# IN THE U NITED STATES PATENT AND TRADEMARK OFFICE

Serial No. 09/547,415

For: FULL COLOR DISPLAY STRUCTURE USING CNC THIN FILM

AMENDMENT (marked-up copy)

Fig. 2(a)

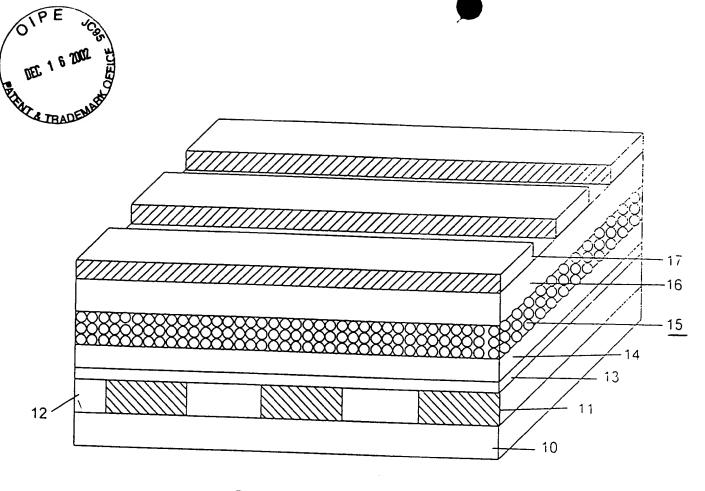
The Examiner objected to the missing reference number 15 in Fig.2(a). The missing number 15 has been added.

The Examiner objected to the missing reference number 15 in Fig.2(a). The missing number 15 has been added.

Please add reference number "15" in Figure 2(a) as attached.
